MEMORANDUM

Date: May 13, 2024

Subject: Transportation System Plan Ordinance Amendments – updated

Figure 1. Bicycle parking: standard spacing requirements

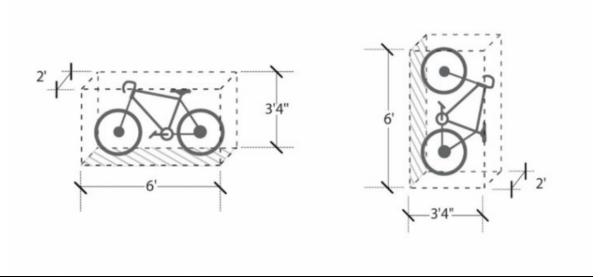
- a. The standards required bicycle space is 2 feet wide, 6 feet long, and 3 feet 4 inches tall as shown in Figure 1 below. There must be at least 5 feet behind all bicycle parking spaces to allow room for bicycle maneuvering as shown in Figure 2 below.
- b. Where short-term bicycle parking is adjacent to a public sidewalk, the maneuvering area may extend into the right-of way. There must be 2 feet 6 inches between the rack and any wall as shown in Figure 2.
